E.1.a.a -2747 Asquith Street: Development Variance Permit No. 00258 (Oaklands)

Committee of the Whole Report For the Meeting of April 1, 2021

Subject: Development Variance Permit Application No. 00258 for 2747 Asquith Street

A-1.0

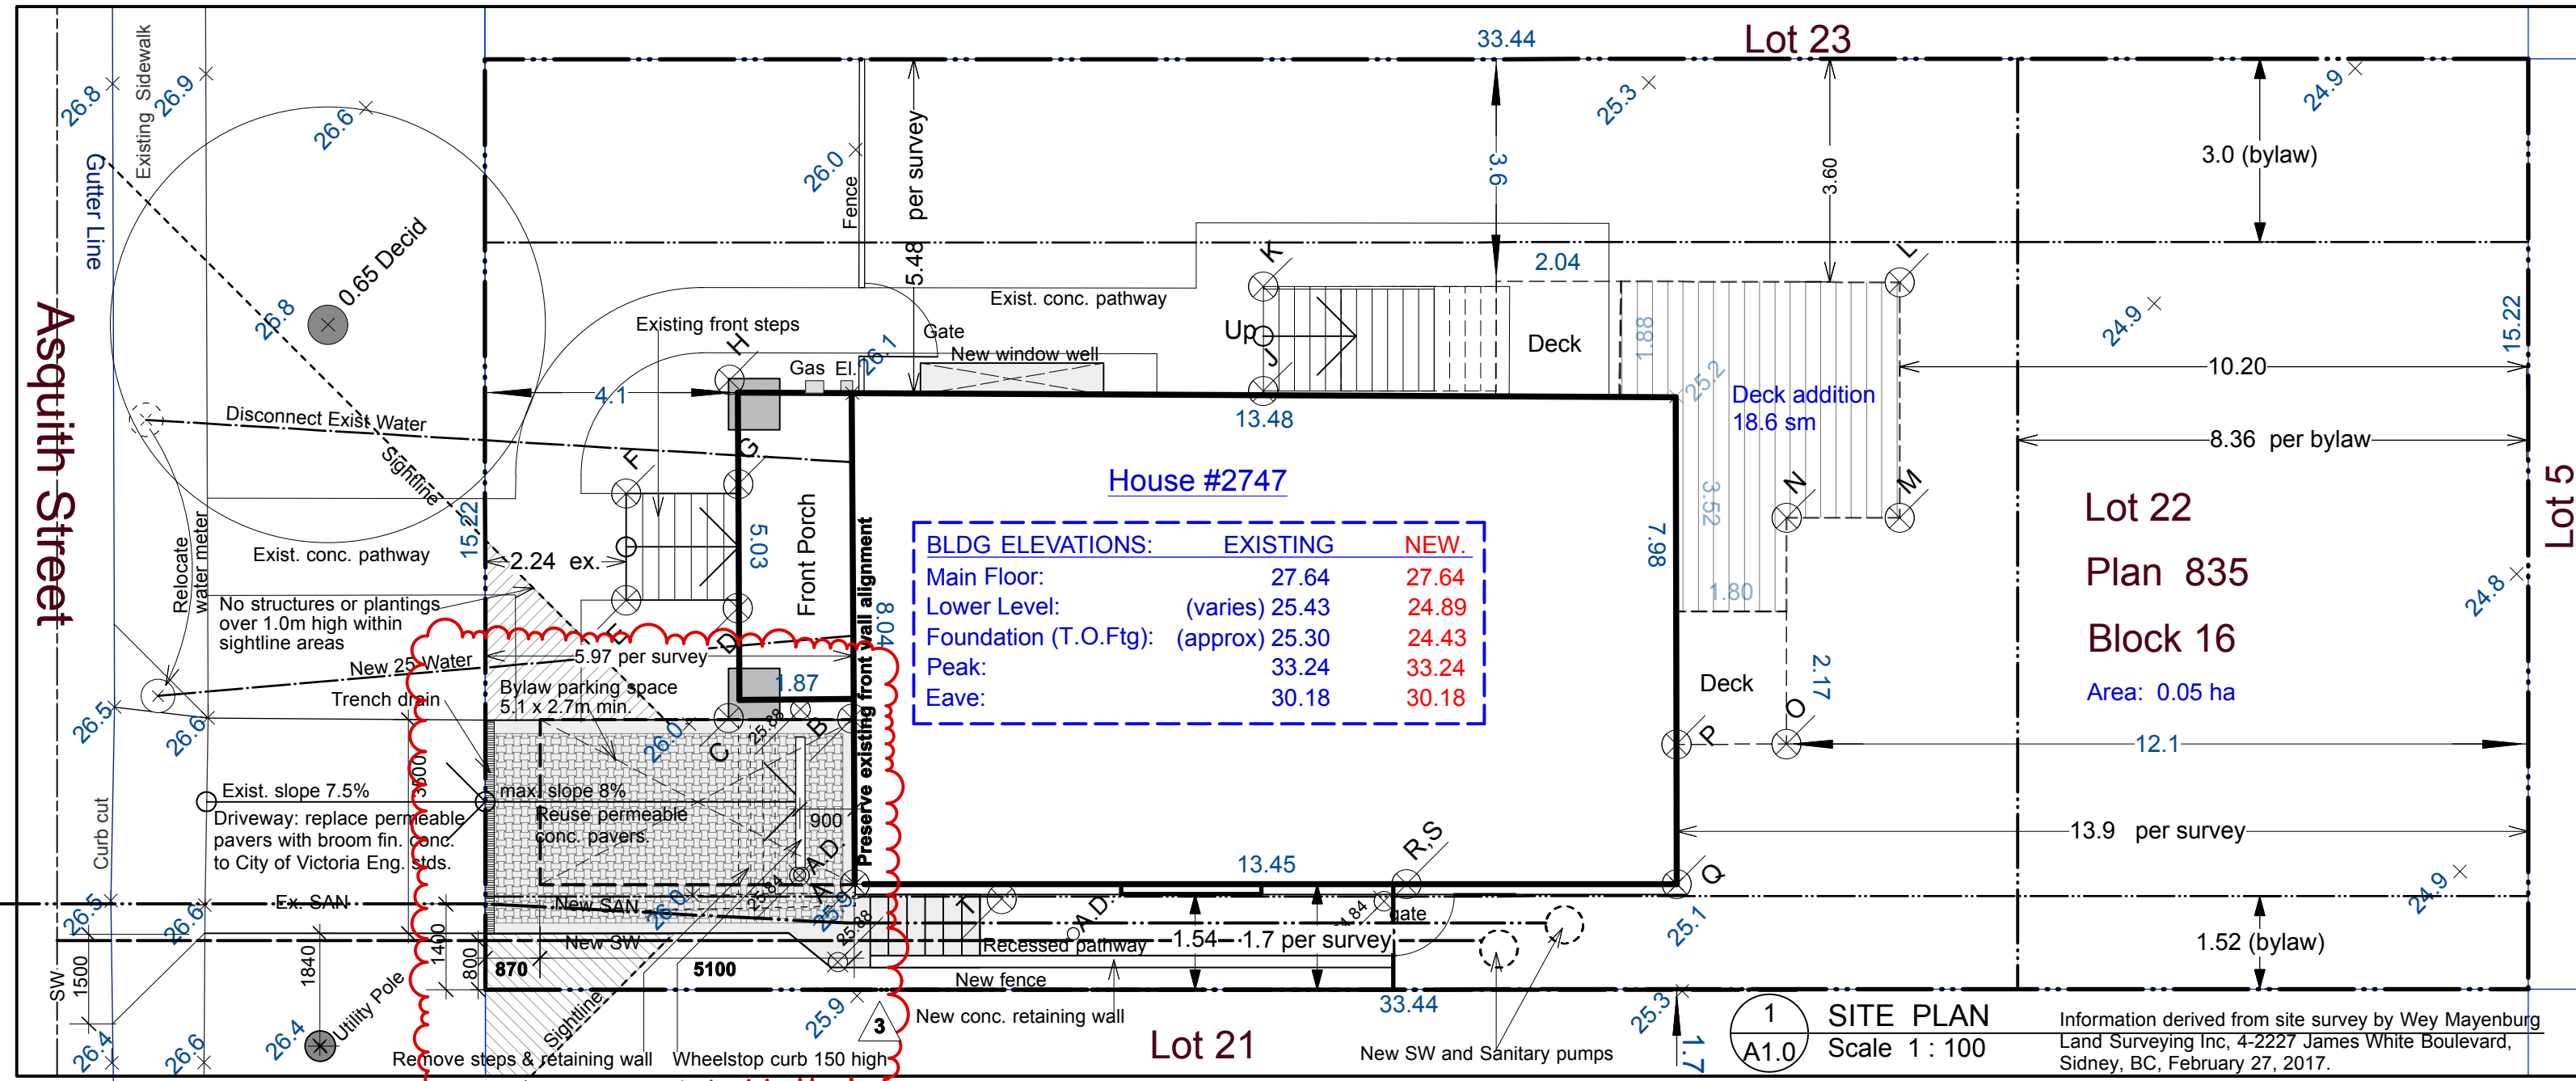
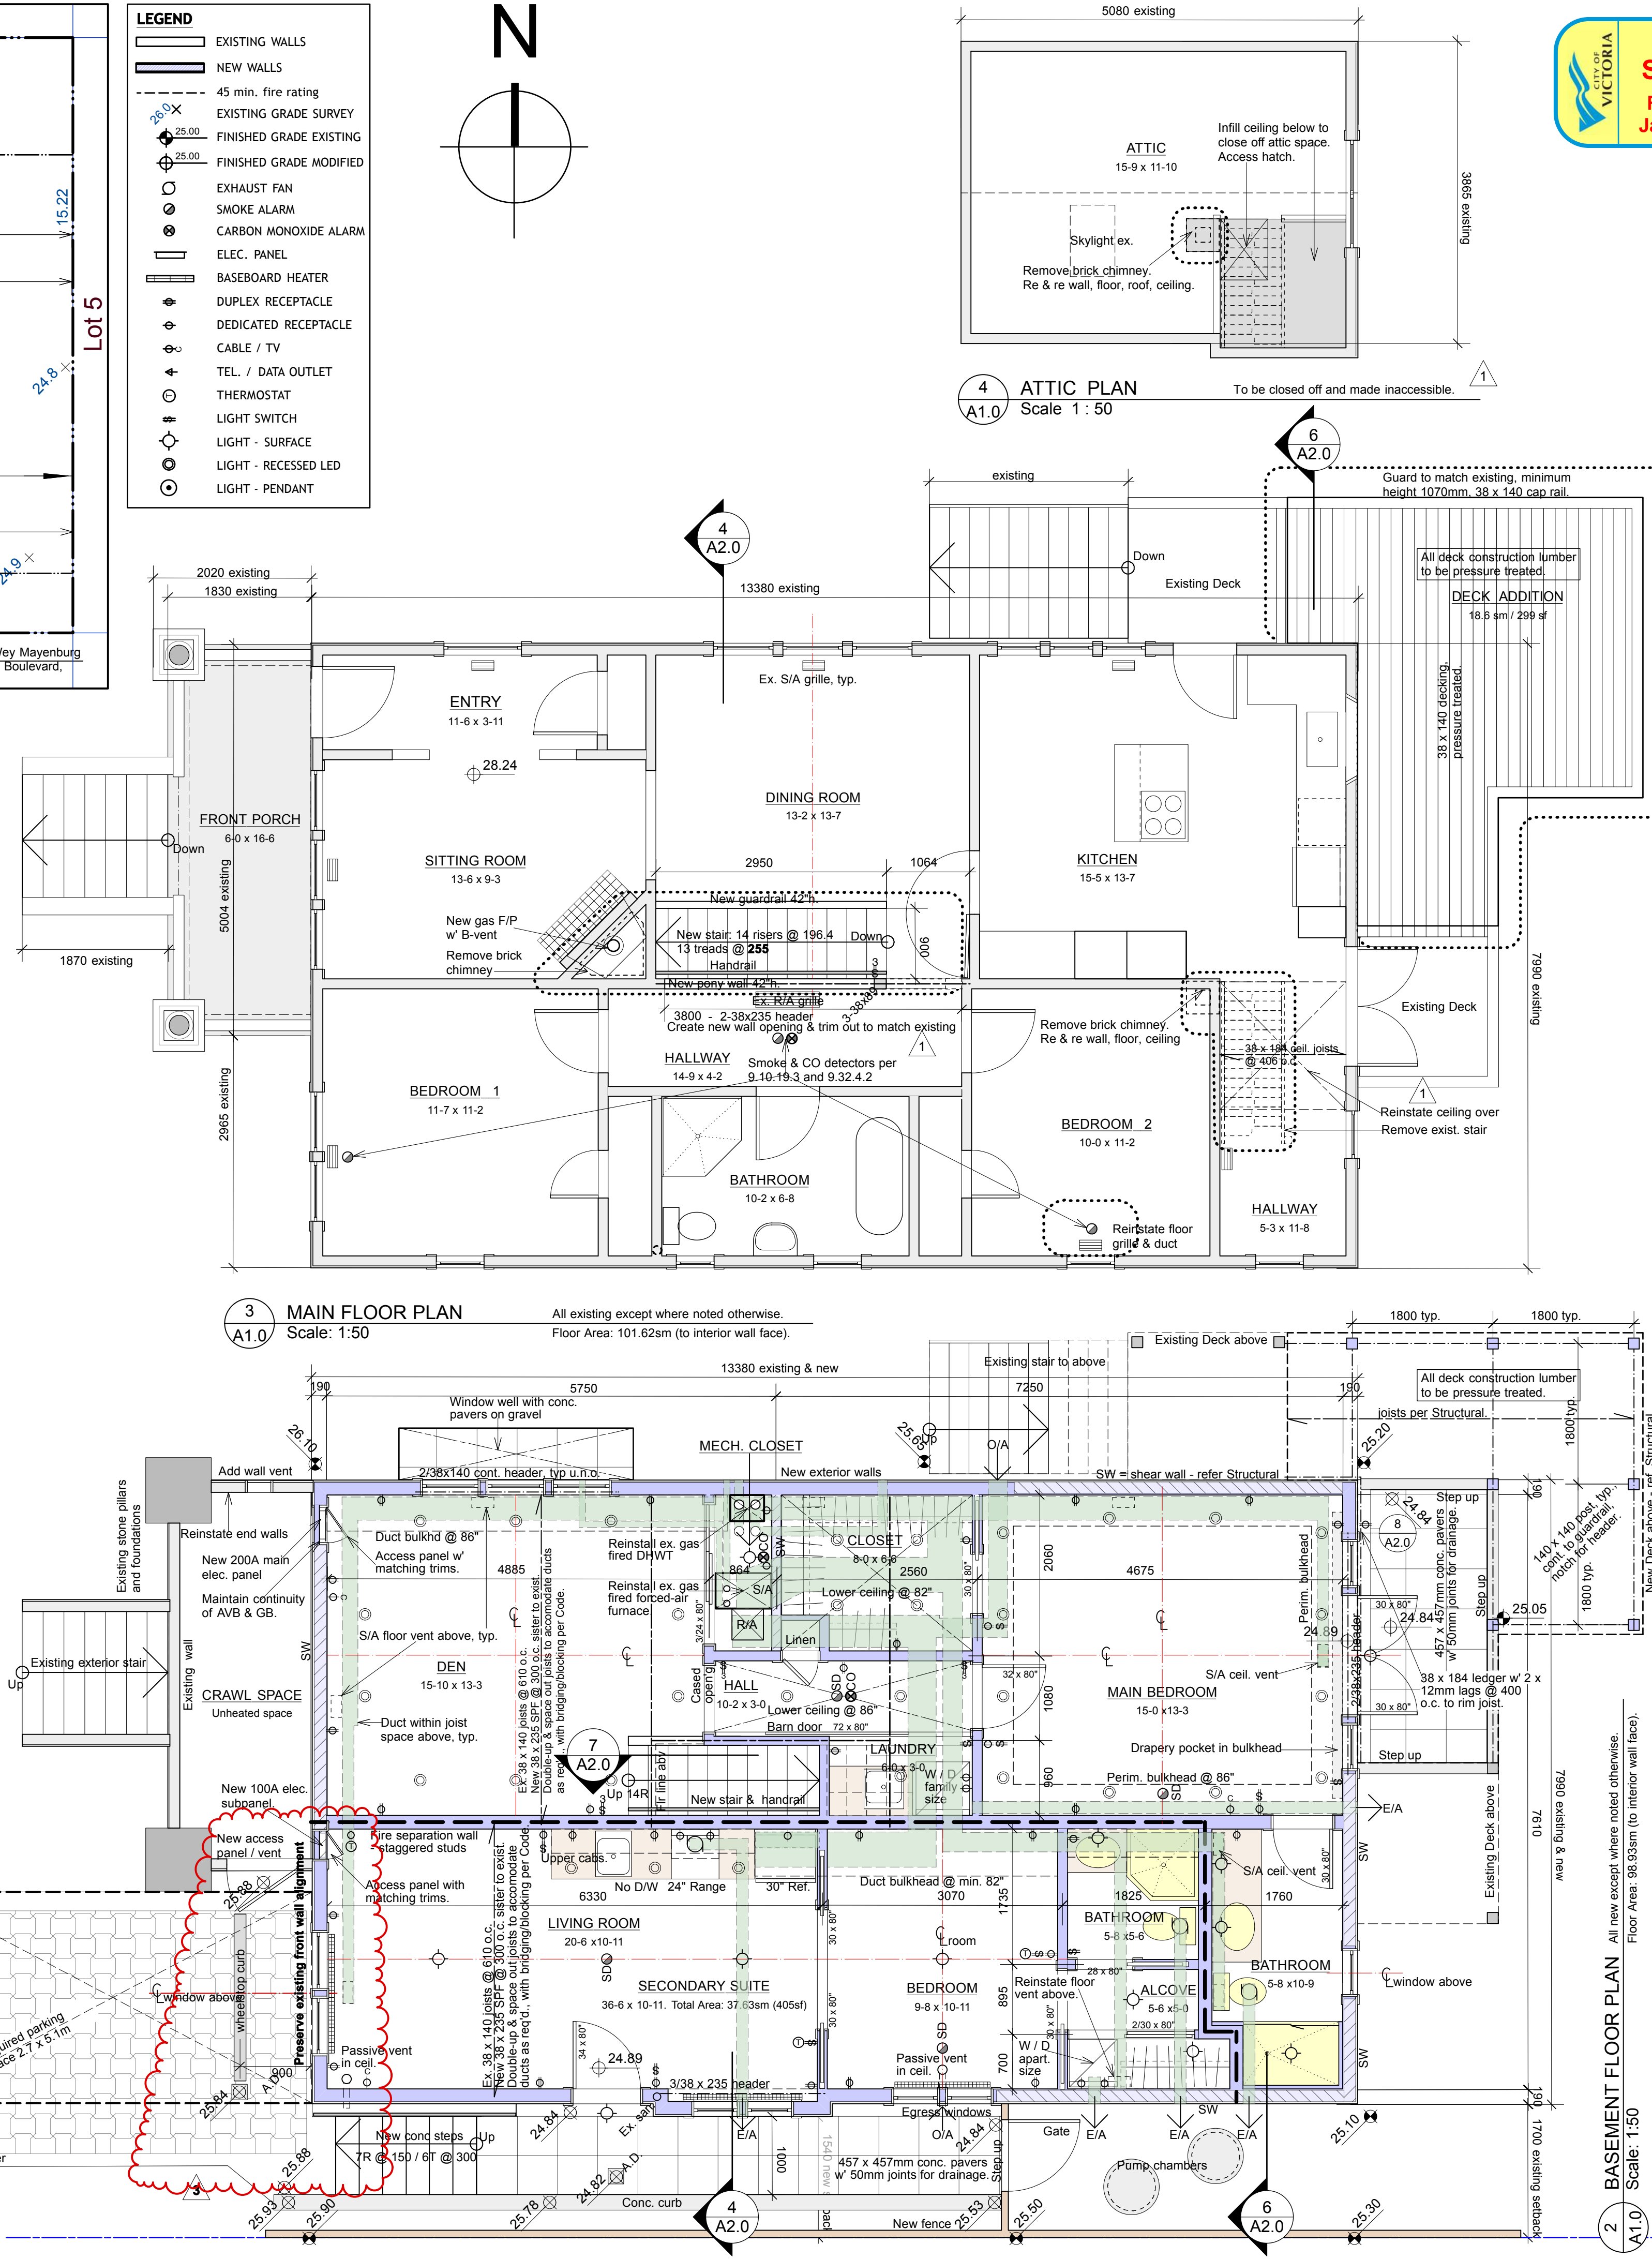
The purpose of this report is to present Council with information, analysis and recommendations for a Development Variance Permit Application for the property located at 2747 Asquith Street. The proposal is to renovate the existing single-family dwelling to create a secondary suite. The proposal meets the required number of parking stalls (one). However, a variance is required to reduce the minimum distance from the parking stall to a street from 1.0m to 0.87m.

- the proposal is consistent with the *Oaklands Neighbourhood Plan* as it maintains the low-scale, family-oriented character of the neighbourhood.
- the variance to reduce the required distance from the parking stall to the street by 0.13m (approximately five inches) is considered supportable since the municipal boulevard provides sufficient buffer to prevent any potential obstruction of the sidewalk.

The existing property operates with a legal non-conforming front yard setback. The proposal meets the required number of parking stalls (one) for a single-family dwelling and secondary suite. The parking stall is located in the front yard as permitted under the bylaw and meets the minimum standards for stall dimensions. However, given the legal non-conforming front yard setback, the proposal cannot meet the required 1.0m distance from a parking stall to a street, without radically altering the exterior façade of the building. The requested variance to reduce this distance to 0.87m is considered supportable since the municipal boulevard provides sufficient buffer to prevent any potential obstruction of the sidewalk.

1. Plans date stamped January 21, 2021.
2. Development meeting all *Zoning Regulation Bylaw* requirements, except for the following variance:
 - i. reduce the minimum distance from the parking stall to a street from 1.0m to 0.87m.
3. The Development Permit lapsing two years from the date of this resolution."
